ADDENDUM NUMBER FIVE

RFQ # 7448230

**TITLE: ARRA – CHAFEE HALL FIRE PROTECTION
UPGRADES - URI**

DOCUMENT 00900 - ADDENDA AND MODIFICATIONS #5

SHEET #: SKA - #4

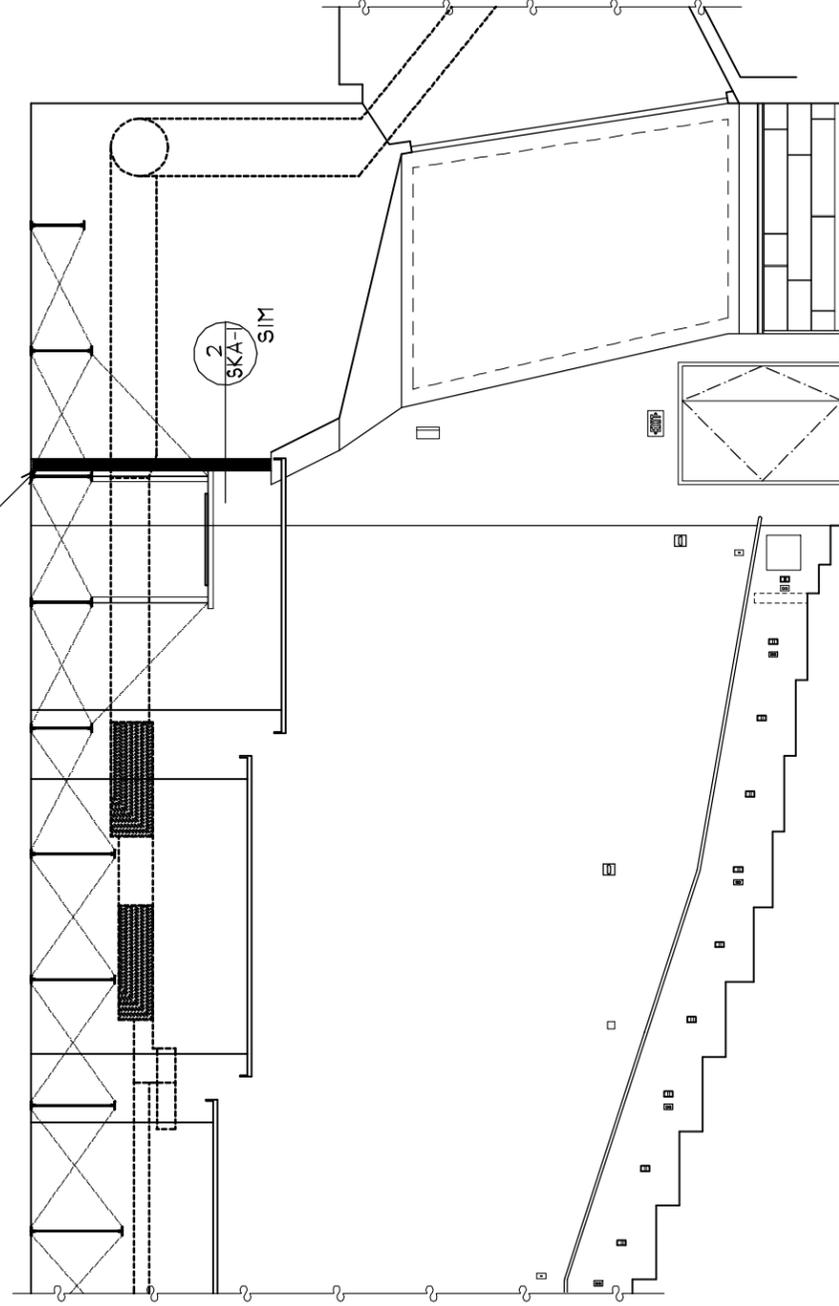
A. Add information to sheets A1.5 and A5.1 per SKA-#4 dated 3/9/11 issued as part of this addendum, attached.

PROVIDE ACCOUSTIC SEPARATION SIMILAR TO DETAIL 2/SKA-1. USE EXISTING FRAMING WHERE AVAILABLE

BLACK INFILL INDICATES SCOPE OF SEPARATION

SHEET #: SKA - #5

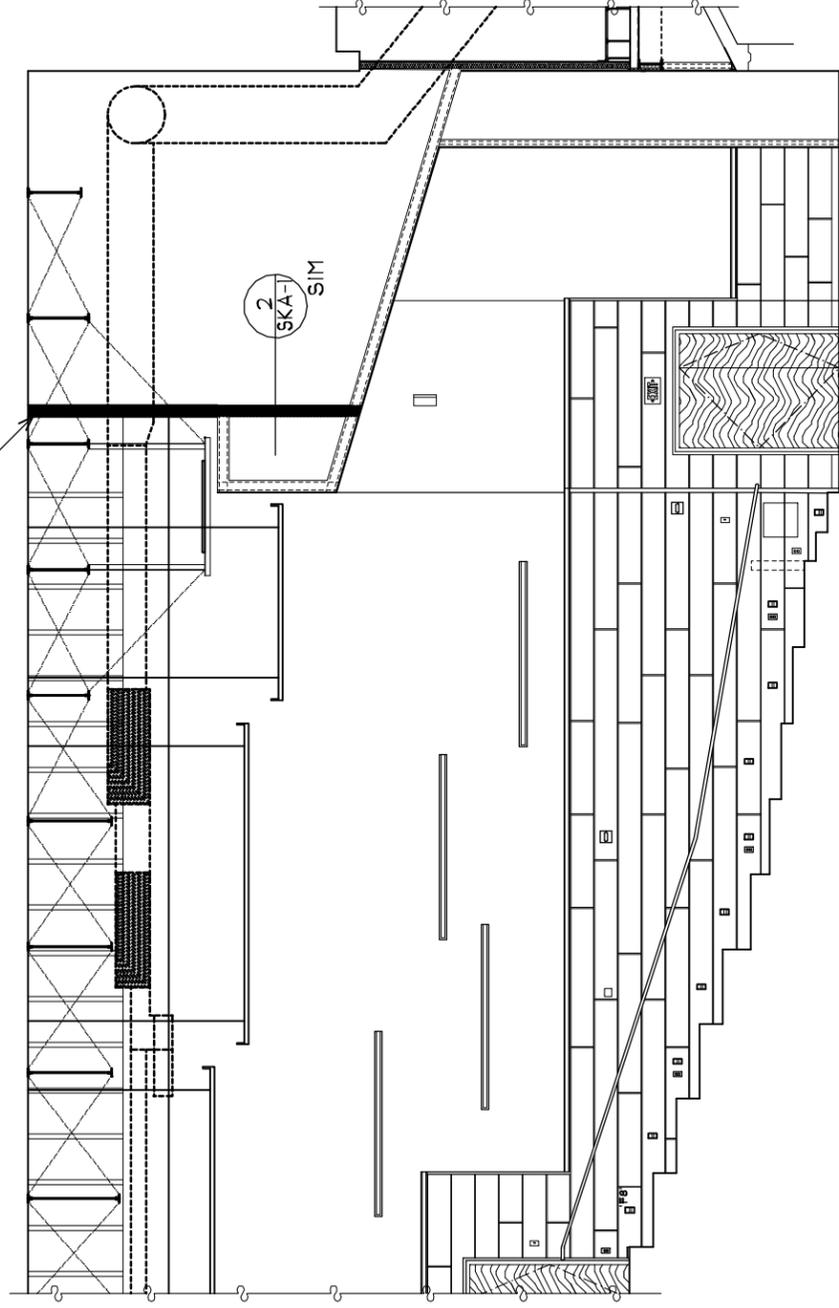
B. Add information to sheets A1.5A and A5.1A per SKA-#5 dated 3/9/11 issued as part of this addendum, attached.

PROVIDE ACCOUSTIC SEPARATION TO UNDERSIDE OF STRUCTURE. REFER TO DETAIL 2/SKA-1

BLACK INFILL INDICATES SCOPE OF SEPARATION
